Author response to interactive comment RC1 submitted on Jul 02, 2021

In the document below, the reviewer comments have been copied from the original review and are shown in black font, while the author comments have been added in blue.

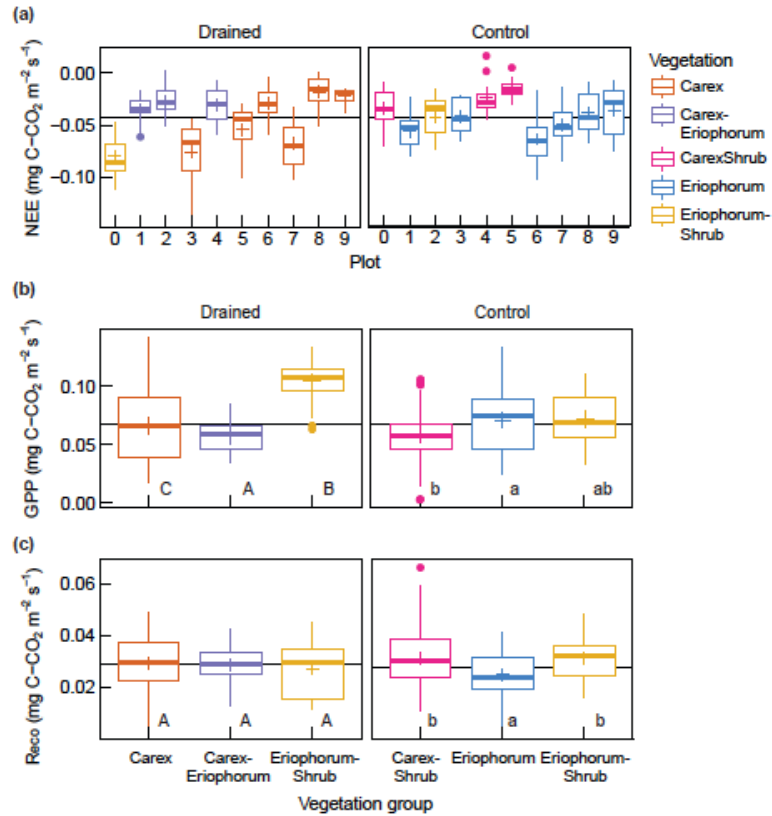
I do not see a simple way to solve this issue, but perhaps simulating data based on flux measurements from Kwon et al 2016, using the relationship between the fluxes in the current study and those in Kwon et al 2016, could allow to carry out a sensitivity analysis to determine whether the choice of these 2 replicates affected the findings.

As demonstrated in Figure 8 from Kwon et al. (2016), which is copied above, there is some spatial variability in CO_2 flux rates along the control transect, so obviously our flux result from the UGR site would have been affected if we had chosen 2 different sites from the set of ten. However, as already outlined above, it was our scope to work with these two sites chosen as references for our study, since they featured the required ecological characteristics, i.e. vegetation community structure and water level status. Only a different scope would have enabled a random site selection since there were more sites to choose from. We agree that revisiting plots across studies is very desirable for intercomparison and to trace ecosystem behavior through time. However, any of the remaining 8 sites would have either been dominated by cotton grasses, or would have featured dry conditions on an elevated ridge. Therefore, a random choice of two

plots out of the 10 available positions would not provide an appropriate approach to find the most suitable references for the scope of the presented study.
